# Product Discontinuation Notice

| Product Discontinuation | Recommended Replacement |
|---|---|
| **CJ1W-ADG41** | **CJ1W-AD042**<br>**NX-HAD401/402** |

## [ Final order entry date ]
The end of March 2024

| Input Circuit Diagram | Input Circuit Diagram |

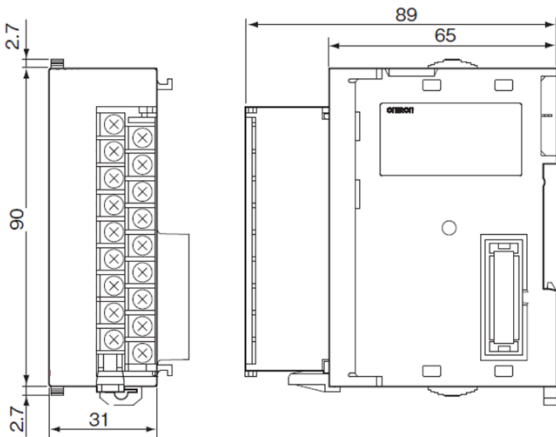
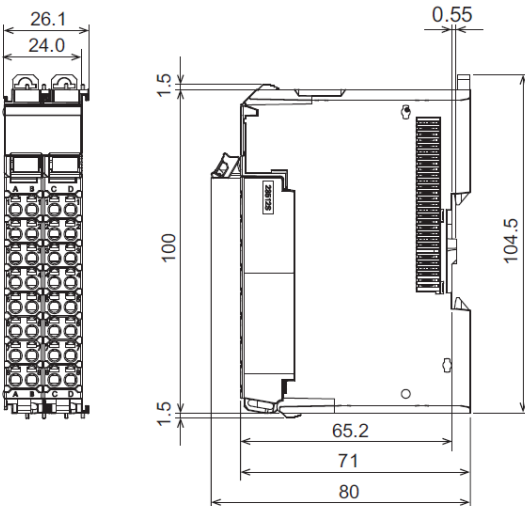
## [ Wire connection ]

| Product discontinuation CJ1W-ADG41 | Recommended replacement 1 CJ1W-AD042 |
| **Terminal Arrangement** | **Terminal Arrangement** |
